STATE OF HAWAII	
DEPARTMENT OF TRANSPORTATION	
HIGHWAYS DIVISION	
PLAN & PROFILE - GENERAL NOTES	
INTERSTATE ROUTE H-1	
WAI'AWA INTERCHANGE	
F.A.I. Proj. No. I-HI-1(46):8	
(PAVING OF H-2 CONNECTION)	
Scale: As shown	
SHEET No.	OF SHEETS

SUPPLEMENT
INB. @ STA. 449+50 to 457+76.47
WAIAWA INTERCHANGE
F.A.I. Proj. No. I-HI-1(46)-8

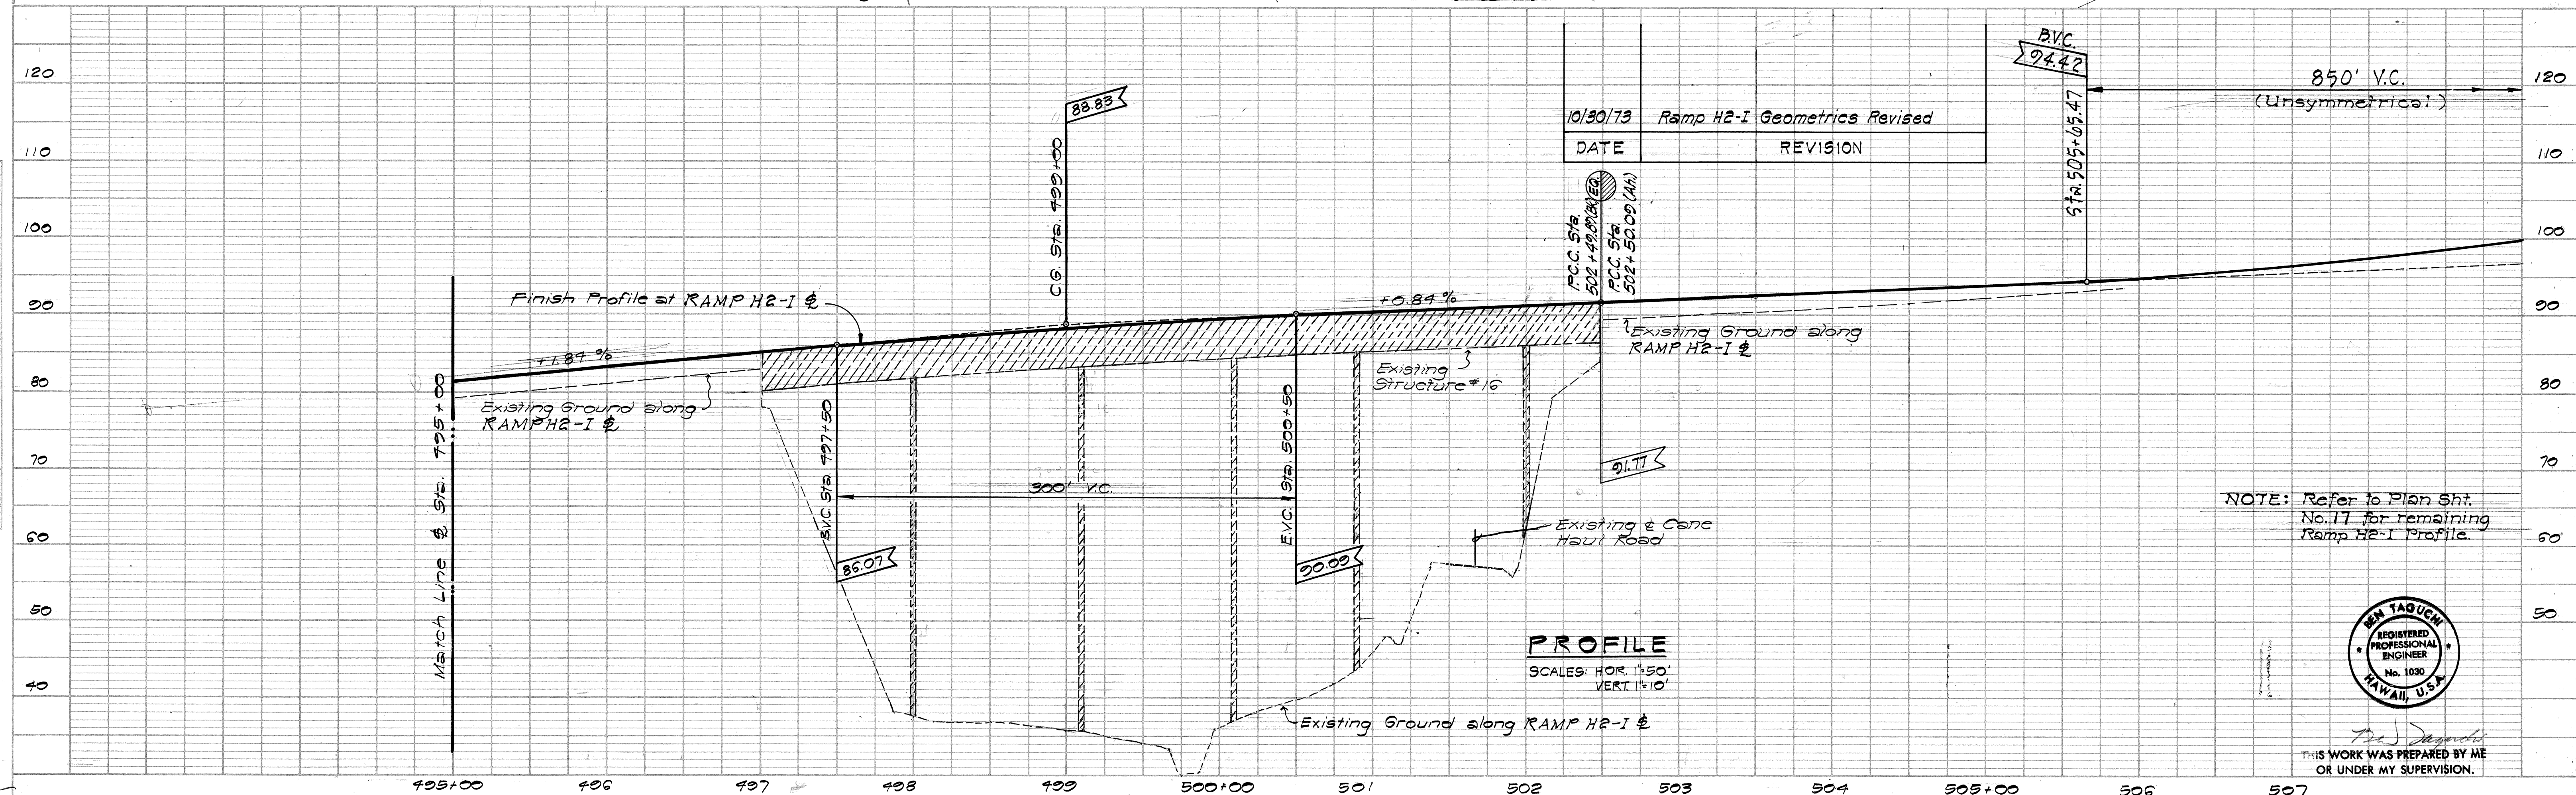
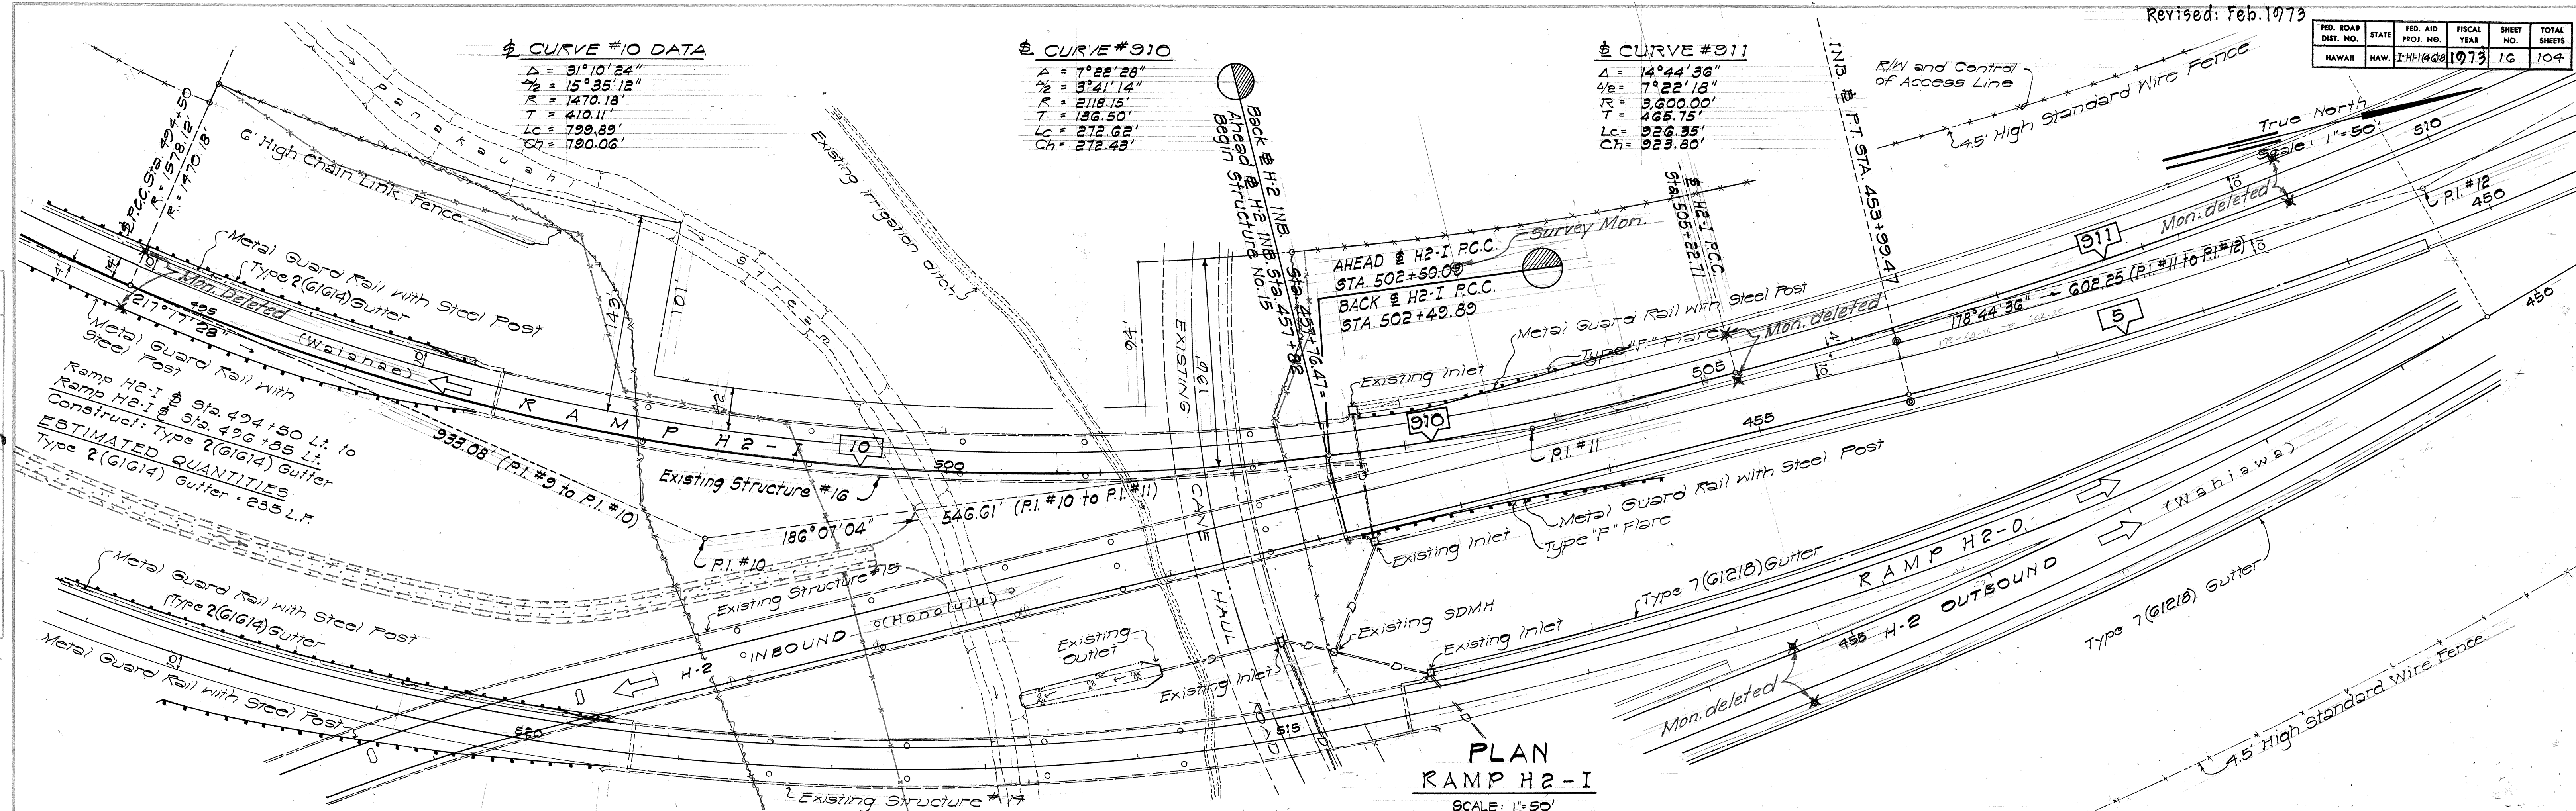
10/30/73	Ramp H2-I Geometrics Revised
DATE	REVISION

PROFILE ~ RAMP H2-1
SCALE: HOR. 1" = 50'
VER. 1" = 10'

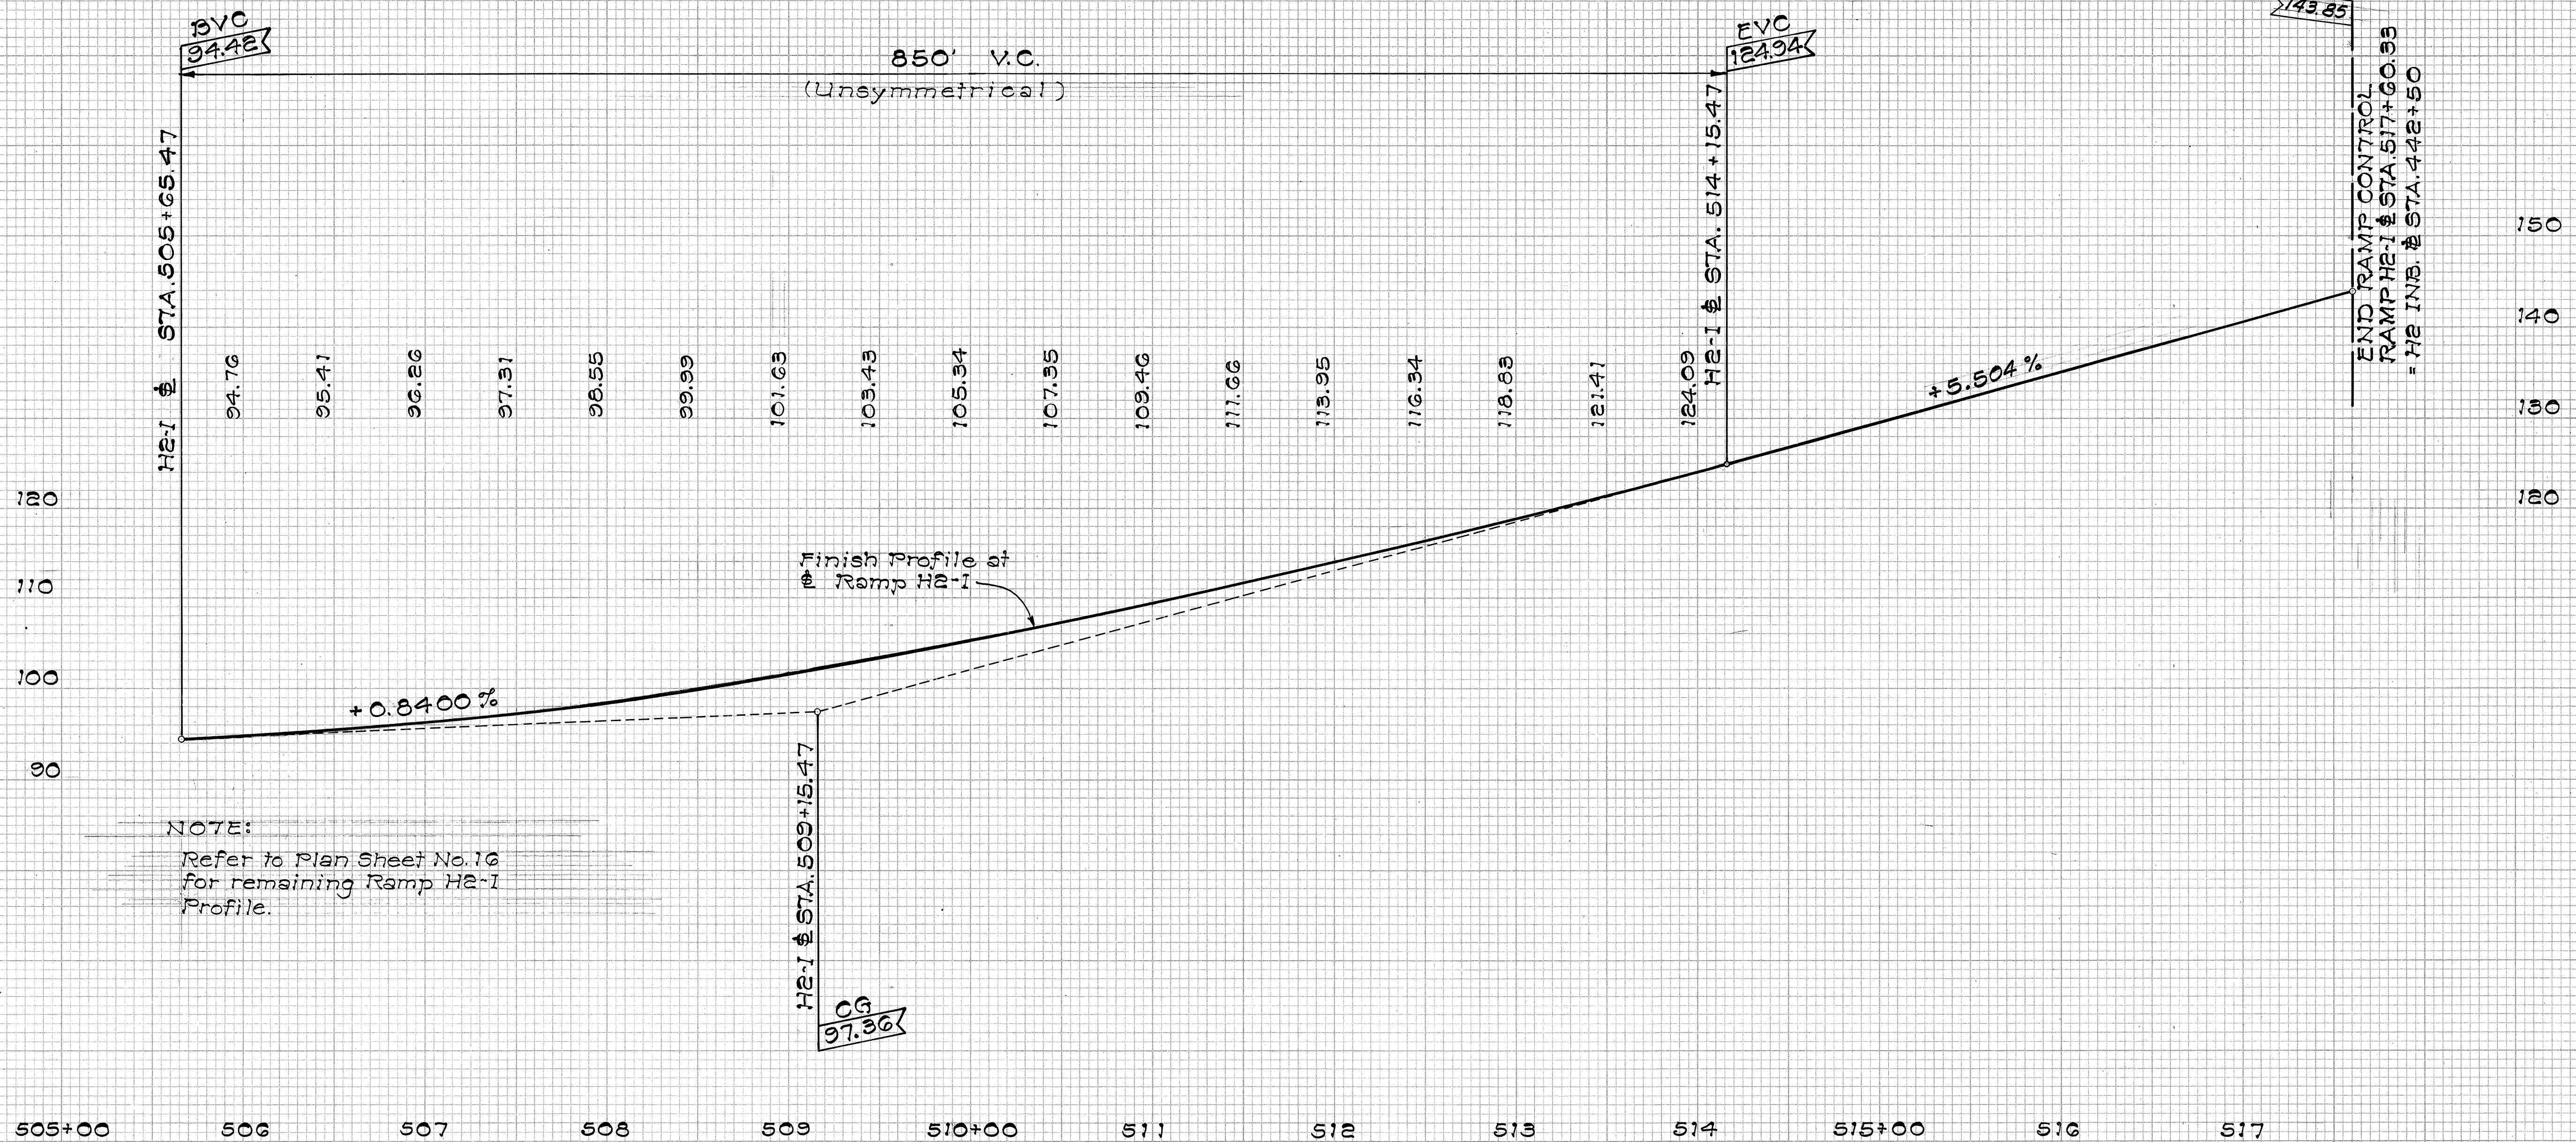
10/30/73	Profile Revised
DATE	REVISION
